**FACT SHEET for State Waste Discharge Permit No. ST-7425**  
**J. H. Baxter & Company**

Re: Response to Your Comments on the Draft Permit and Fact Sheet,  
Permit No. ST-7425,  
J. H. Baxter & Company, Inc. facility, Arlington, Washington

Re: Response to Comments on the Draft Permit No. ST-7425  
J. H. Baxter & Co. Facility, Arlington, Washington

Figure 5.

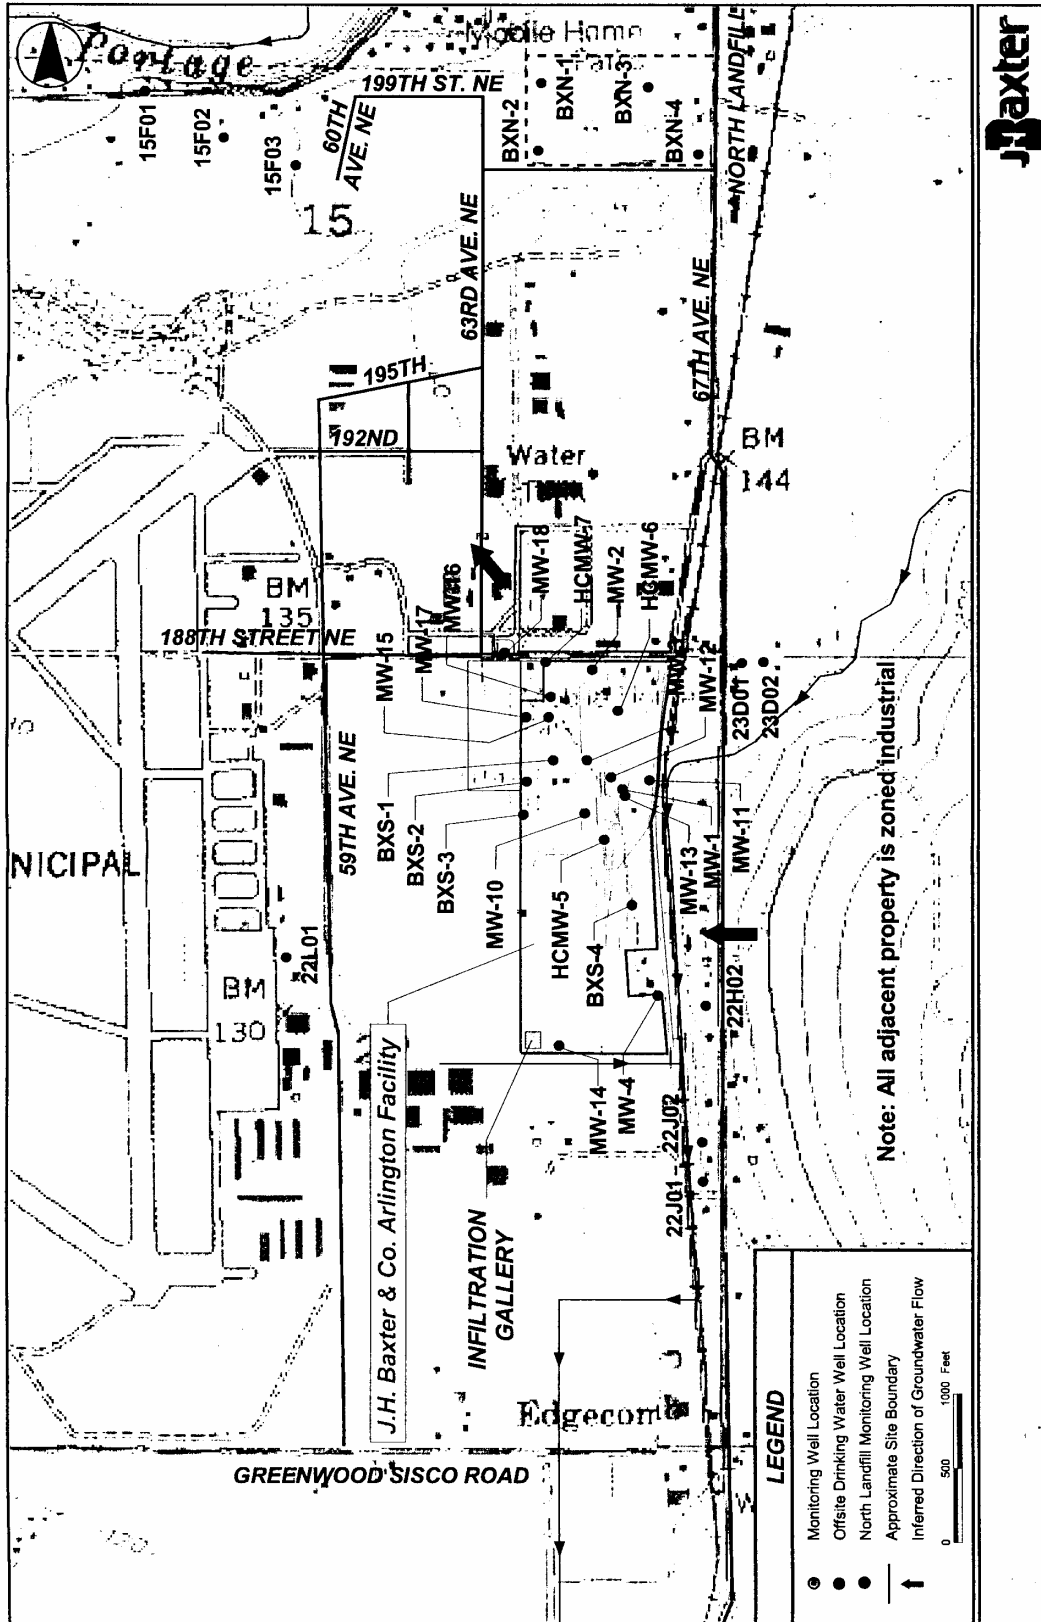
Baxter's comment 9, page 6: Under Ground Water, the second sentence is incorrect. There was no mobile home residence on the property acquired by J. H. Baxter on January 7, 2002. Additionally, Baxter believes that the correct Figure citation is Figure 5.

Department's response: Correction will be made in the fact sheet.
